May, 2020

Response to 1st Review Comments
The Palmeraie – 7-ZN-2016#2

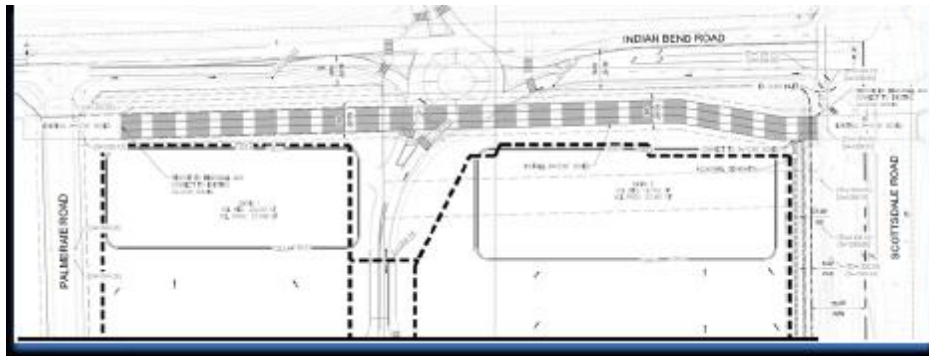
- h. The Engineer must show/call out the locations, size, and invert elevations of all storm drain pipes and box culverts in sections A-A & B-B as appropriate. The Engineer must also show the limits of the proposed D.E. in sections A-A & B-B as appropriate. The rule of establishing the limits of the proposed D.E. over a storm drain pipe or over a box culvert was explained to the Engineer in a meeting and this rule must be verified and followed when dedicating

the proposed D.E. over a storm drain pipe or over a box culvert. It should be noted that more cross-sections maybe requested by the reviewer during the Improvement Plans review. (DSPM, Sec. 4-1A)

SD profiles have been included in this submittal as a part of the preliminary drainage report. Limits of required drainage easements have been provided on preliminary grading plans.
